SUBJECT: ISSUANCE OF AMENDMENTS FOR THE PALO VERDE NUCLEAR GENERATING STATION
UNIT NO. 1 (TAC NO. M94541), UNIT NO. 2 (TAC NO. M94542), AND UNIT
NO. 3 (TAC NO. M94543)

The Commission has issued the enclosed Amendment No. 108 to Facility Operating License No. NPF-41, Amendment No. 100 to Facility Operating License No. NPF-51, and Amendment No. 80 to Facility Operating License No. NPF-74 for the Palo Verde Nuclear Generating Station, Unit Nos. 1, 2, and 3, respectively. The amendments consist of changes to the operating licenses and Technical Specifications in response to your application dated January 5, 1996, as supplemented by letters dated April 19, 1996, May 1, 1996, and May 10, 1996.

This amendment would revise the operating licenses and TS Section 1.26 to increase the authorized rated thermal power. The amendment also would revise TS 4.1.1.4, 3.1.3.4, and 3.2.6 (Figure 3.2-1) to lower the allowable reactor coolant system cold leg temperature limits for each of the three PVNGS Units, and revise TS 3.4.2.1 and 3.4.2.2 to lower the pressurizer safety valve setpoints by 25 psia for Units 1 and 3. The Unit 2 pressurizer safety valve setpoints in TS 3.4.2.1 and 3.4.2.2 were revise

FIGURE 3.2-1
REACTOR COOLANT COLD LEG TEMPERATURE VS. CORE POWER LEVEL

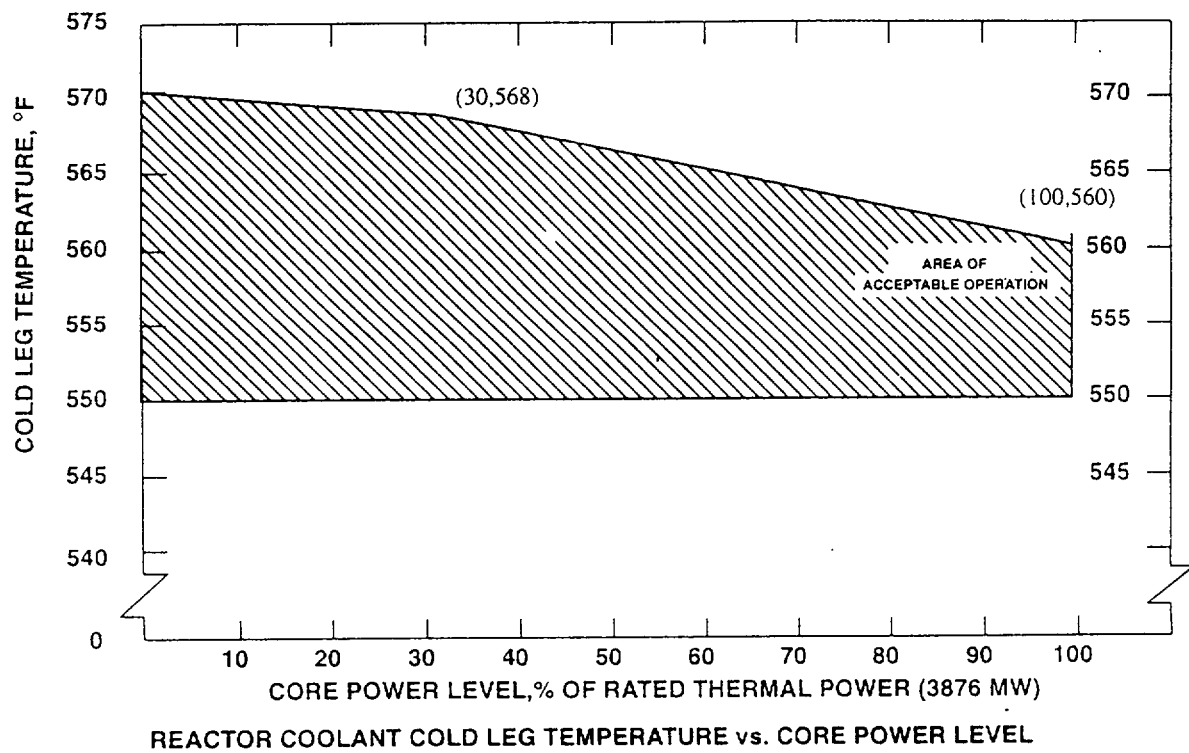
Revise TS 3.2.6 (Figure 3.2-1). The current allowable T_{cold} upper range limit is a curve that begins at 570°F at 0 percent power, drops linearly to 568°F at 30 percent power, and remains at 568°F up to 100 percent power. The revised T_{cold} upper range limit for the area of acceptable operation would begin at 570°F at 0 percent power and drop linearly to 568°F at 30 percent power, as in the current Figure 3.2-1, but then drop linearly to 560°F at 100 percent power. The lower T_{cold} range limit for the area of acceptable operation would be reduced from the current limit of 552°F at all power levels to 550°F at all power levels.

3.2.6 The reactor coolant cold leg temperature (T_c) shall be within the Area of Acceptable Operation shown in Figure 3.2-1.
